U.S. Department of the Interior
BUREAU OF LAND MANAGEMENT

Well Name: BETH GEIGER	Well Location: T23N / R7W / SEC 17 / NENE / 36.231842 / -107.590866	County or Parish/State: RIO ARRIBA / NM
Well Number: 1	Type of Well: CONVENTIONAL GAS WELL	Allottee or Tribe Name:
Lease Number: NMNM58877	Unit or CA Name:	Unit or CA Number:
US Well Number: 300392450600S1	Well Status: Producing Gas Well	Operator: EPIC ENERGY LLC

Notice of Intent

Type of Action: Plug and Abandonment

Beth Geiger #1**Proposed P&A****Lybrook Gallup****935' FNL & 905' FEL, Section 17, T23N, R7W, Rio Arriba County, NM****API: 30-039-24506****Hole Size: 12-1/4"**

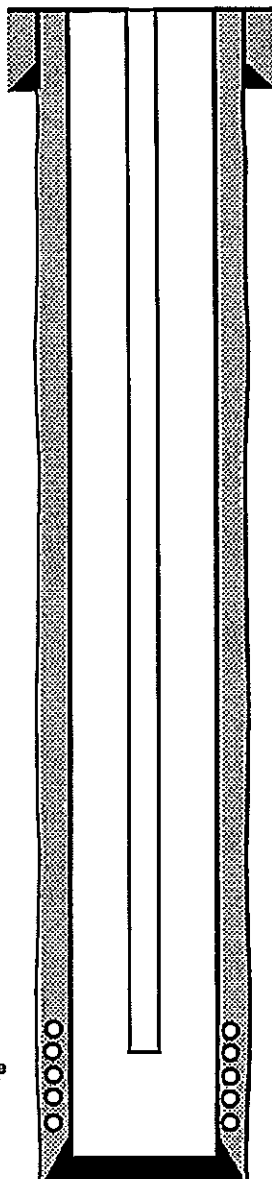
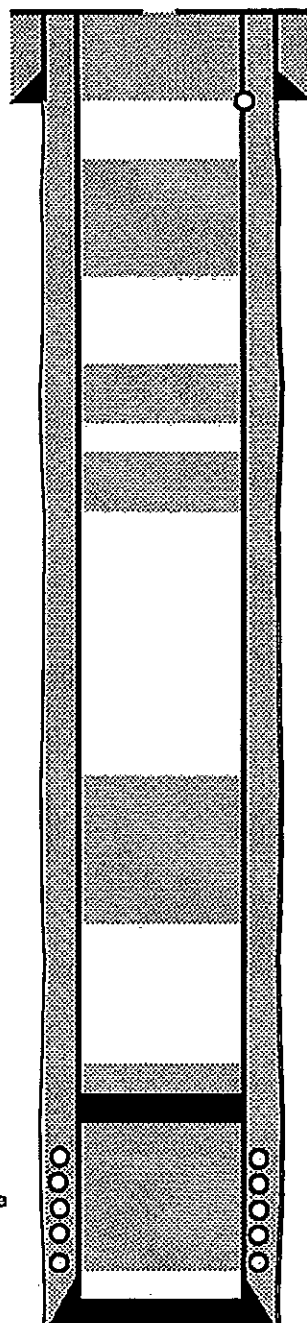
1. Plugging operations authorized are subject to the attached "General Requirements for Permanent Abandonment of Wells on Federal and Indian Lease."
2. Farmington Office is to be notified at least 24 hours before the plugging operations commence (505) 564-7750.
3. The following modifications to your plugging program are to be made:
 - a) Plug 2 (Mancos): Adjust to cover the interval from 4705' to 4555'.
 - b) Add a plug to cover the top of the Mesaverde (Cliff House) at 2892'.
 - c) Plug 3 (Chacra): Bring the top up to 2416' to cover the BLM formation top pick.
 - d) Add a plug, or bring the top of Plug 4 up to cover the Fruitland formation at 1878'.
 - e) Bring the bottom of Plug 6 down to 301' to cover the 50 feet below the surface casing shoe.

- BLM picks for the top of the Gallup, Fruitland, Kirtland, and Ojo Alamo formations vary from Operator submission.
- Adjust Plug #2 (Mancos) to cover the interval from 4705' – 4555'.
- Add a plug to cover the top of the Mesaverde (Cliff House) at 2892'.
- Bring the top of Plug #3 (Chacra) up to 2416' to cover BLM formation top pick.
- Add a plug, or bring the top of Plug #4 up, to cover the Fruitland formation top at 1878'.
- Bring the bottom of Plug #6 (surface) down to 301' to cover 50 feet below the surface casing shoe.
- The plugs proposed in the P&A procedure, with recommended changes, will adequately protect any freshwater sands in this well bore.
- Gallup perms 5327' – 5715'.

You are also required to place cement excesses per 4.2 and 4.4 of the attached General Requirements.
